Edwin I. Hatch Nuclear Plant
Request for Temporary Technical Specifications Revision:
Allow Power Uprate Testing

Bases for Change Request

Additional Bases for Change Request

FIGURE 1
 PLANT E. I. HATCH
 POWER VS. FLOW MAP

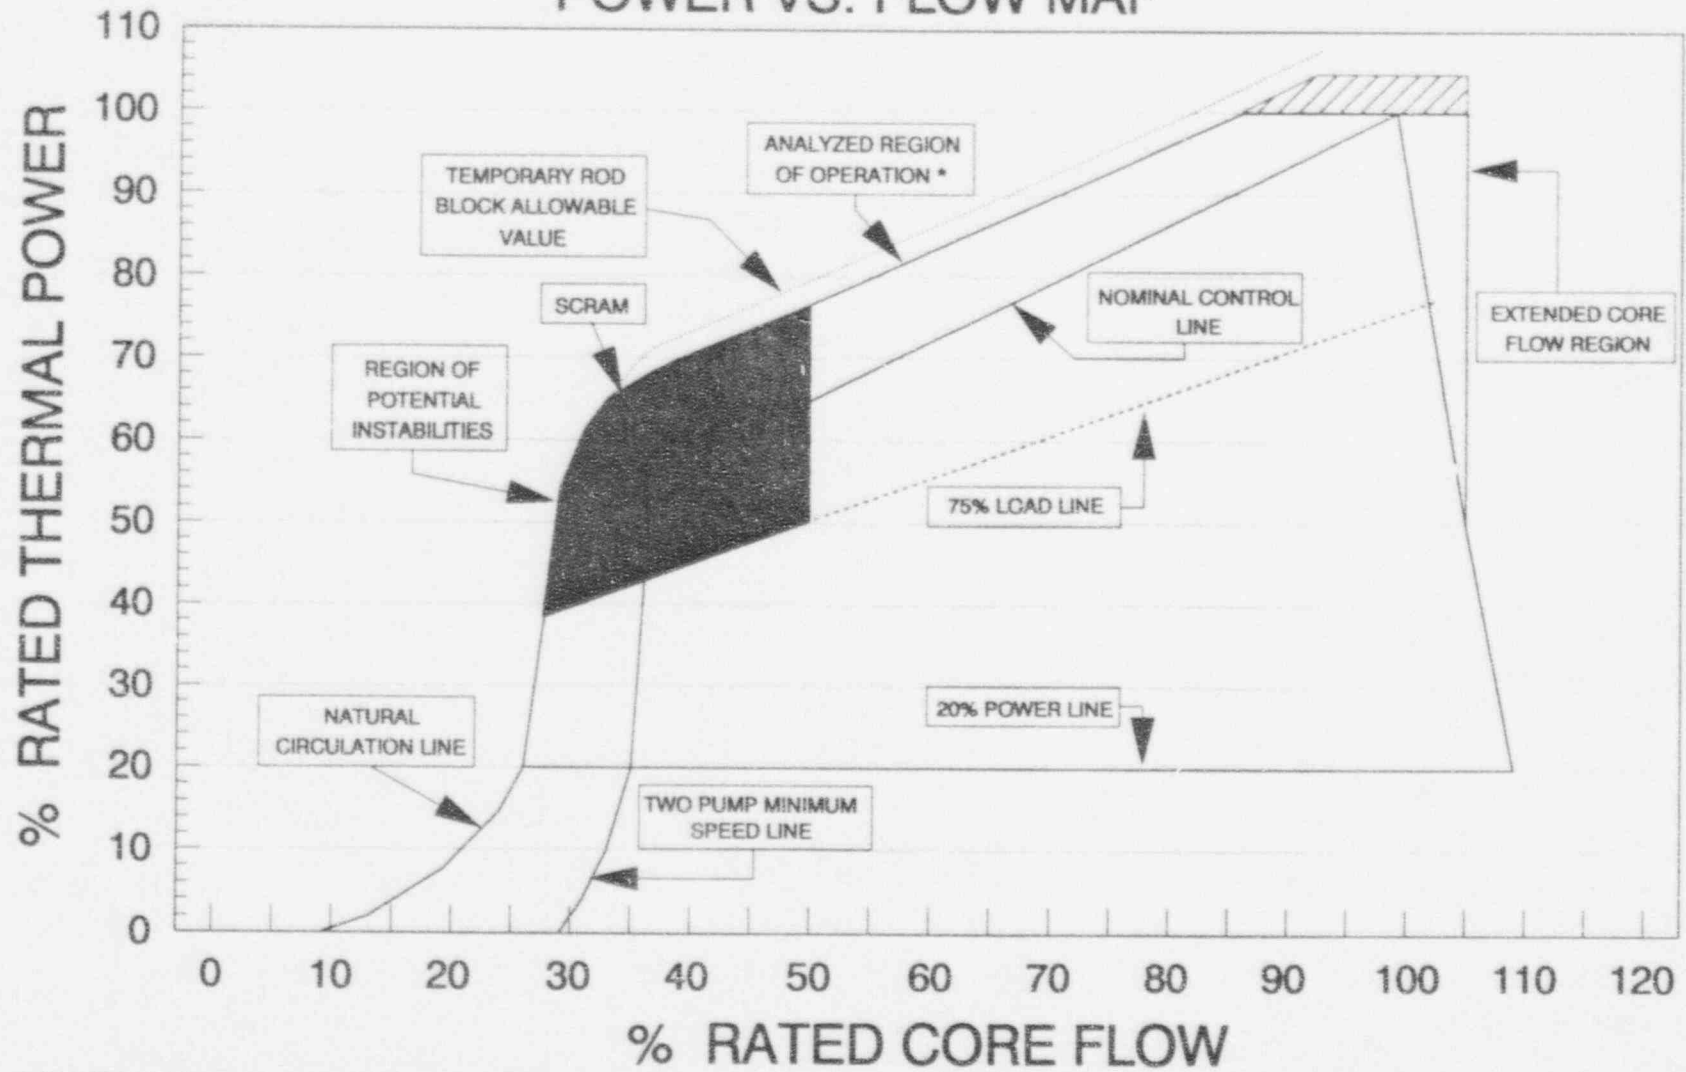
The power-to-flow map will not be changed for test purposes, except to allow operation at power levels above 100%. Figure 1 presents the Plant Hatch power versus flow map. Enclosure 1, Proposed Change 3 discusses the temporary change to the APRM rod block equation.

Enclosure 1, Proposed Change 3 details the bases for the 3% change requested for the test. The request is necessary because a combination of conservative APRM rod block nominal trip setpoints and normal APRM noise alarms restrict operation at rated power below 95% core flow. This change will provide more plant maneuvering capability to reach higher power.

* TEMPORARY ROD BLOCK NOMINAL TRIP SETPOINT
